ATTACHMENT B

RPV Thermal and Pressurization Limits  
Revised Technical Specification Pages:

ATTACHMENT C

RPV Thermal and Pressurization Limits  
Marked-Up Technical Specification Pages

**FIGURE 3.6.1**  
**PILGRIM REACTOR VESSEL**  
**PRESSURE - TEMPERATURE LIMITS**  
**HYDROSTATIC AND LEAK TESTS**

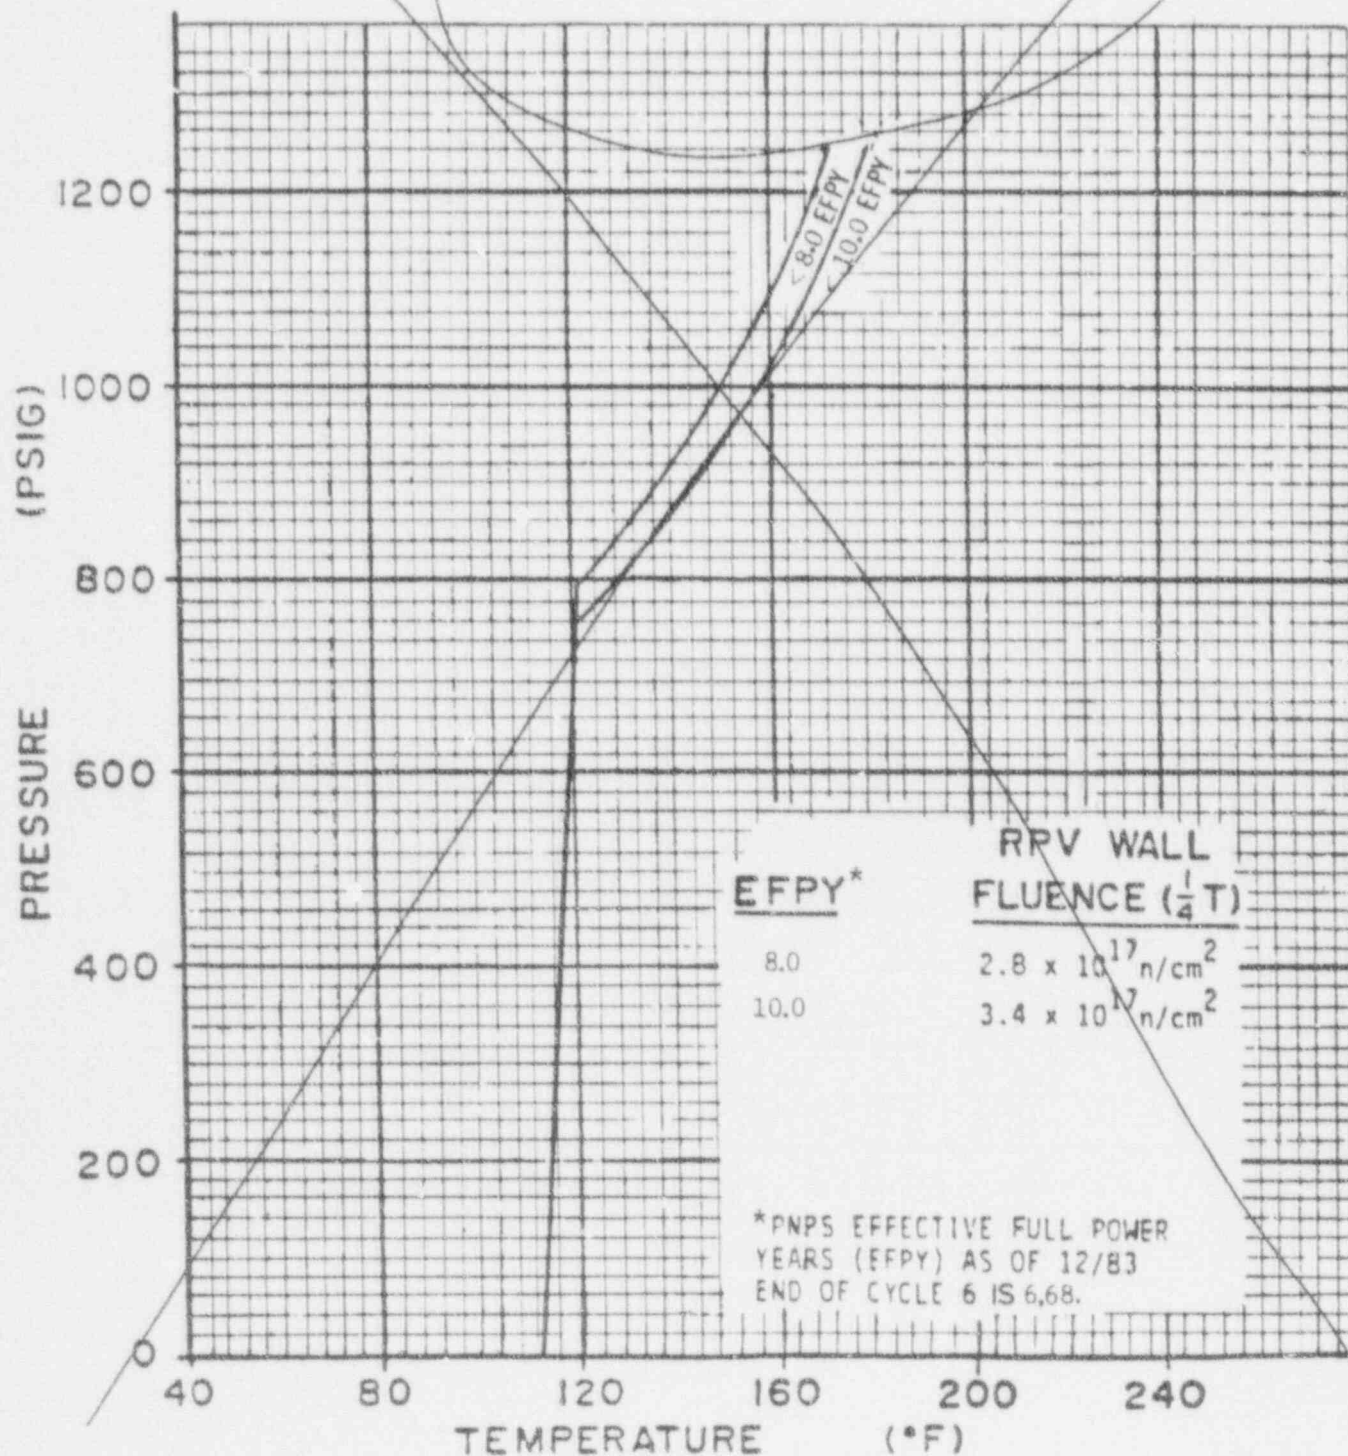
*Replace with  
new Figure 3.6.1*

FIGURE 3.6.2

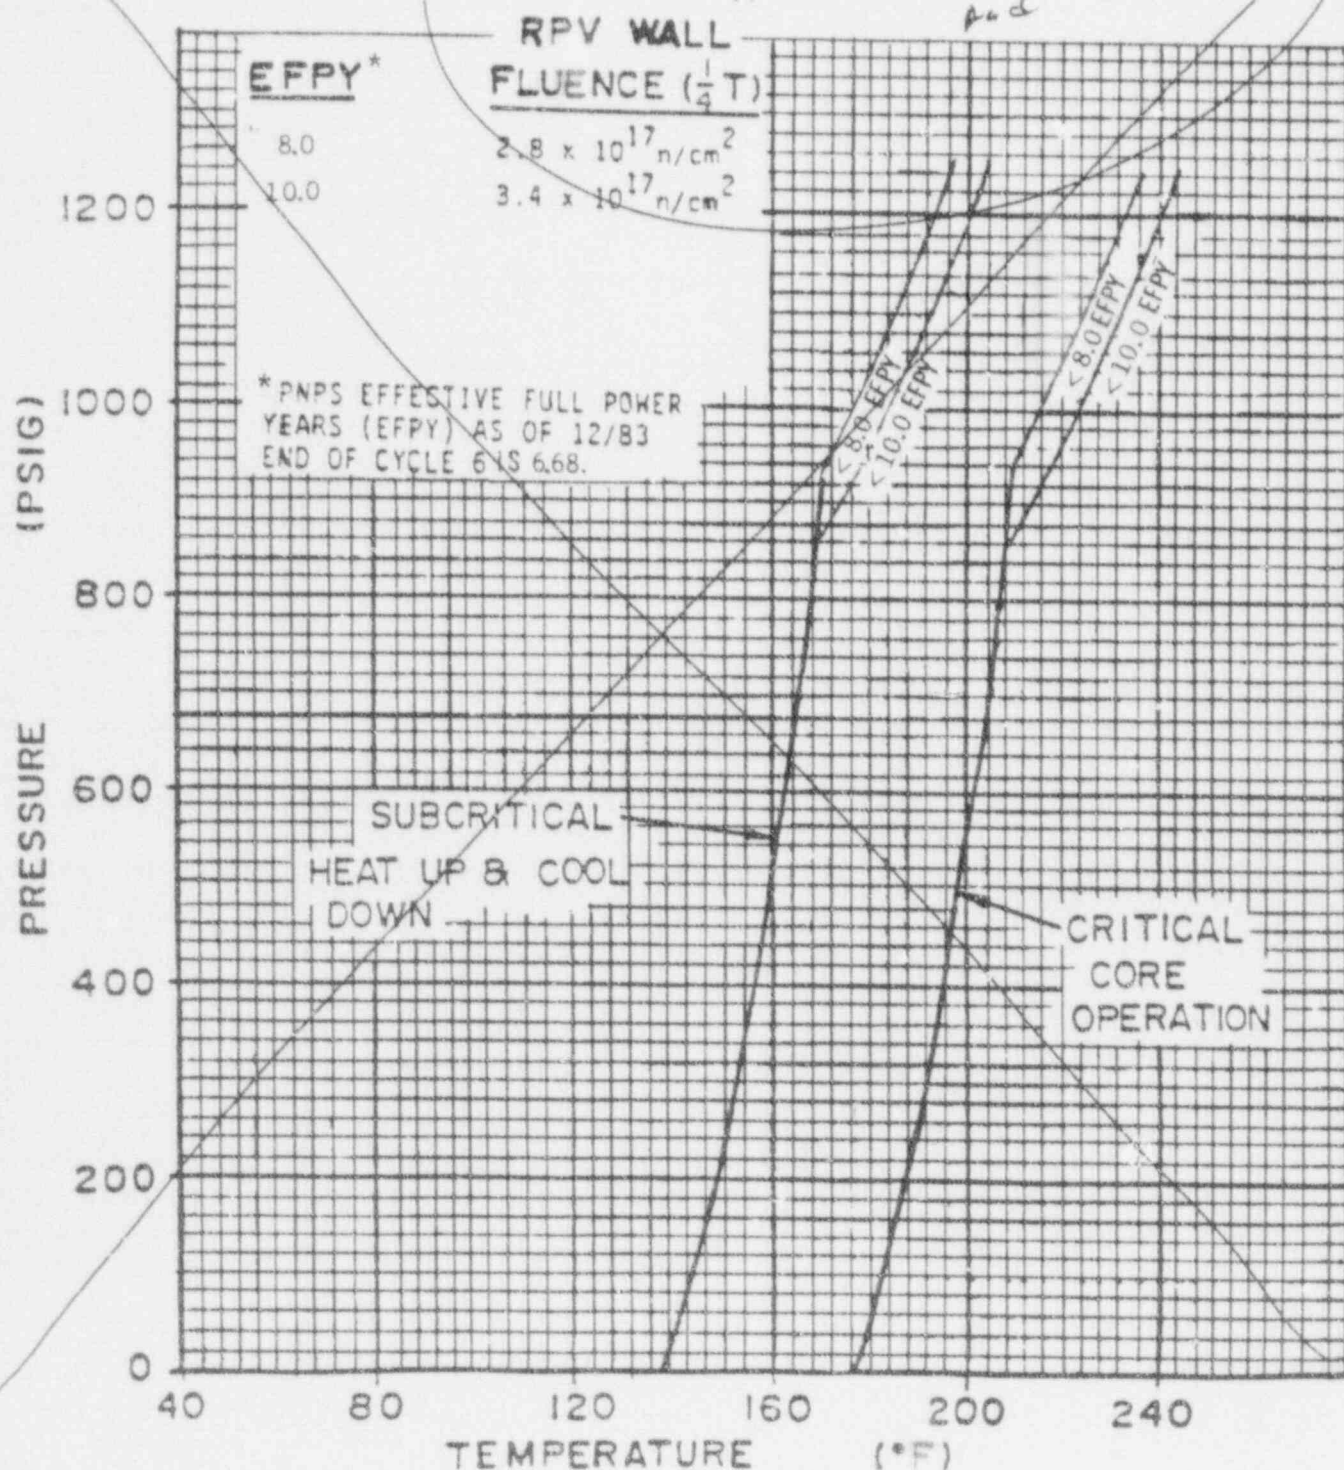
At stated pressure, the reactor vessel bottom head may be maintained at temperatures below those temperatures corresponding to the adjacent reactor vessel shell as shown in Figures 3.6.1 and 3.6.2.
